**23-2336**26 October
2023**TECHNICAL SERVICE BULLETIN****12.3 Inch Instrument Panel Cluster (IPC) Display Screen Without Head Up Display (HUD) - IPC Bezel Misaligned To IPC Display Screen - Built On Or Before 15-Aug-2023****Model:**

Ford 2023 F-Super Duty	Built on or before 15-Aug-2023
----------------------------------	--------------------------------

Figure 1

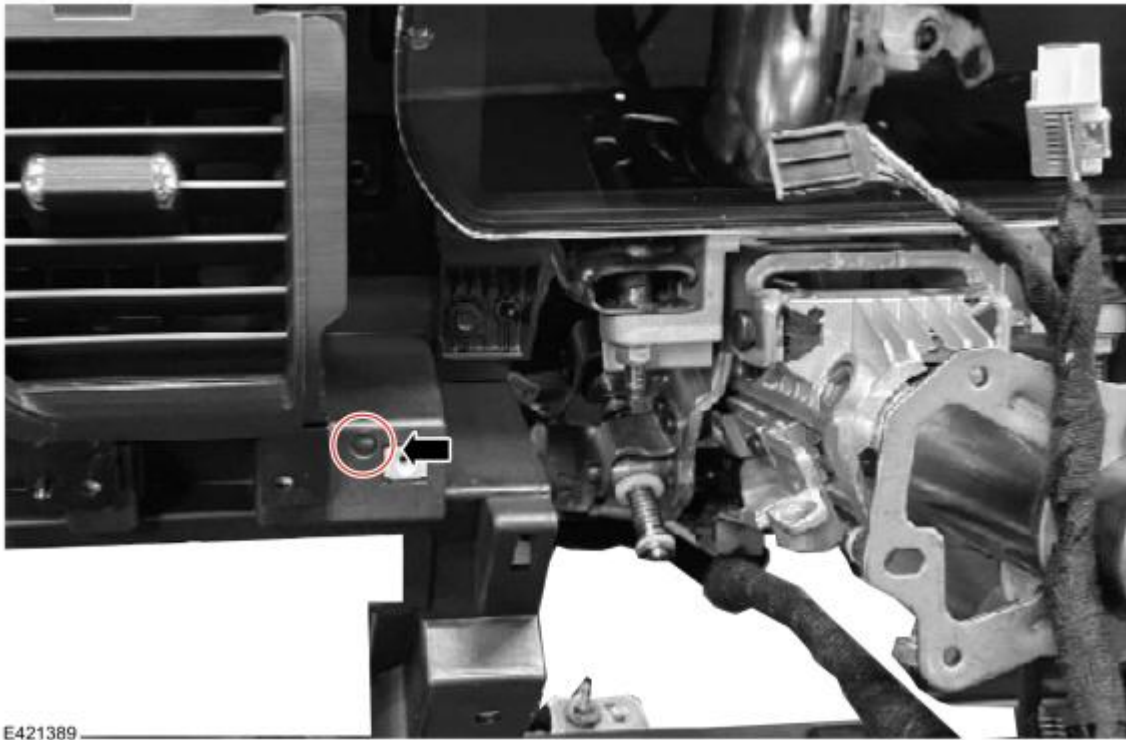
Issue: Some 2023 F-Super Duty vehicles built on or before 15-Aug-2023, equipped with a 12.3 inch IPC display screen and no HUD may exhibit the IPC bezel misaligned to the IPC display screen in lower left corner. This may be due to the locating holes in the instrument panel substrate for the IPC bezel. To correct the condition, follow the Service Procedure to drill out the lower left side locator hole.

1. Remove the IPC bezel. Refer to Workshop Manual (WSM), Section 413-01 > Removal and Installation > Instrument Panel Cluster (IPC) Display Screen - Vehicles With: 12.3 Inch Instrument Cluster Display Screen, Steps 1 through 11.
2. Drill out the lower left locator hole using a 7/16 in. (11mm) drill bit. (Figure 1)
